SUBSURFACE WASTEWATER DISPOSAL SYSTEM APPLICATION

PROPERTY LOCATION		>> CAUTION: PERMIT REQUIRED -- ATTACH IN SPACE BELOW <<	
City, Town, or Plantation	AUGUSTA		
Street or Road	ROUTE 105 <i>1093 So Belfast Ave</i>		
Subdivision, Lot #			
OWNER/APPLICANT INFORMATION			
Name (last, first, MI)	HASKELL, THERESA <input checked="" type="checkbox"/> Owner <input type="checkbox"/> Applicant		
Mailing Address of Owner/Applicant	P O BOX 210 WINDSOR, ME 04363		
Daytime Tel. #	445-5215	Municipal Tax Map # <u>64</u> Lot # <u>10</u>

Subject: Approval, Replacement System Variance Request, Haskell property, South Belfast Avenue (Route 105), Augusta

SUBSURFACE WASTEWATER DISPOSAL PLAN

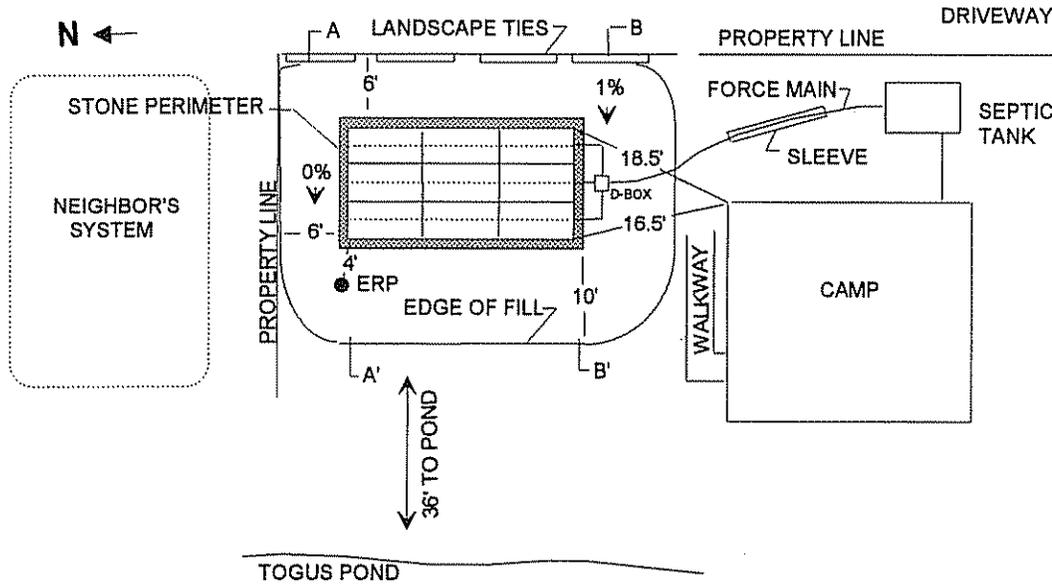
The Division has reviewed a Replacement System Variance Request for the subject property. The proposal is to install a replacement septic system to serve a two-bedroom dwelling. The state variances requested are to allow the installation of the system with a setback distance reduction from a major watercourse to the disposal field of 38 feet and septic tank of 40 feet. Other variances required are setback distance reductions from a structure without a full basement to the disposal field of 14 feet, a property line to the disposal field of six feet, and a fill extension grade reduction to 3:1 along the driveway and property line. The system design, prepared by William Brown, SE, dated November 21, 2002, indicated the replacement system will be further from the watercourse than of the existing system. The design is found to be in compliance with the Maine Subsurface Wastewater Disposal Rules.

We approve the requested variance with the following requirements:

1. A permit for system installation is to be obtained from the Local Plumbing Inspector in advance of the start of system construction.
2. The system is to be installed in accordance with the submitted and approved system design. Should alterations be required at the time of system installation, the system designer must be notified prior to making any changes.
3. The variance approval is based only on the rules administered by this department. The approval of the variance request does not relieve the property owner from compliance with all other state and local requirements pertaining to the installation, use, and operation of the wastewater disposal system.
